Subject: Comanche Peak Steam Electric Station Independent Assessment Program -  
Response to CASE Questions

Comanche Peak ASLB Hearings  
Response to CASE Questions  
Question No.: Walsh #1  
Exhibit No.: None

Comanche Peak ASLB Hearings  
Response to CASE Questions  
Question No.: Doyle #9  
Exhibit No.: 892

WELD PROPERTIES FOR  
PIPE/STANCHION AND ELBOW/STANCHION CONNECTIONS  
FOR  
COMANCHE PEAK PROJECT  
PROCEDURE SA 3912

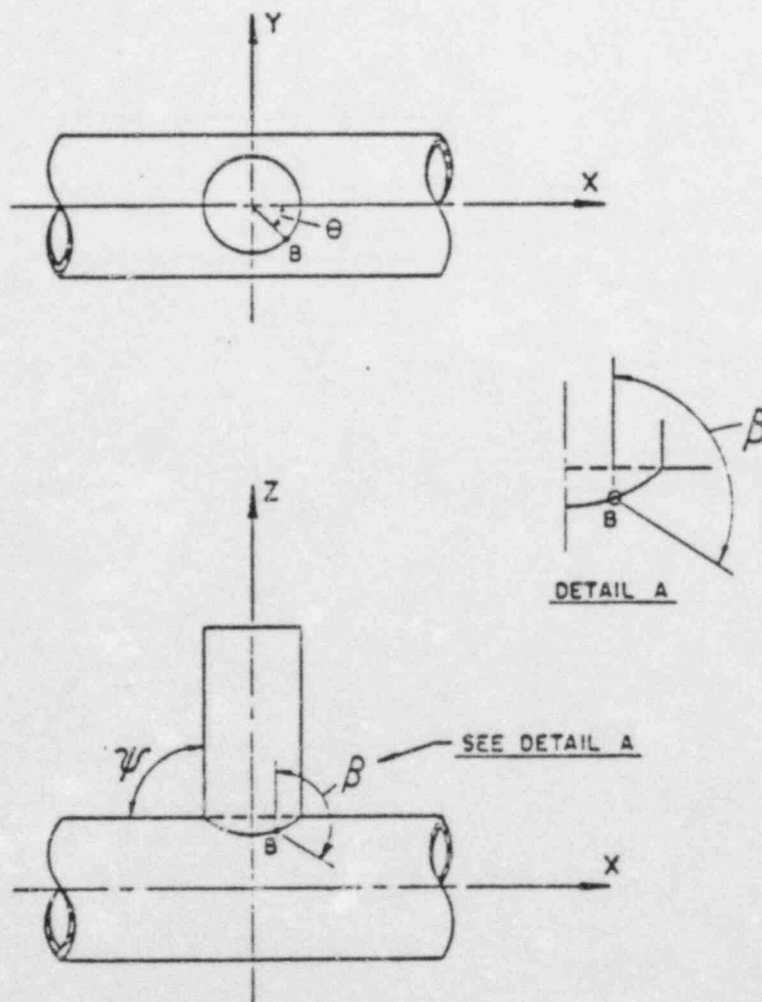
The reduction of weld capacity in the calculation is based on 135 degrees. Actual tangential angle is 150.3 degrees. Therefore, an error exists. Did Cygna take note of this?

- More stress in weld than stated.
- Wide/thin ratio induces cracking as well as the 1.4:1 ratio of width to depth.

What was the basis for concluding that the stanchion-to-pipe weld shown in CASE Exhibit 892 is adequate?

ITT Grinnell design procedure, SA 3912, (attached) states that credit shall only be taken for the portion of the weld up to 135 degrees. Cygna concurred with this procedure and confirmed that it was properly employed on the subject support.
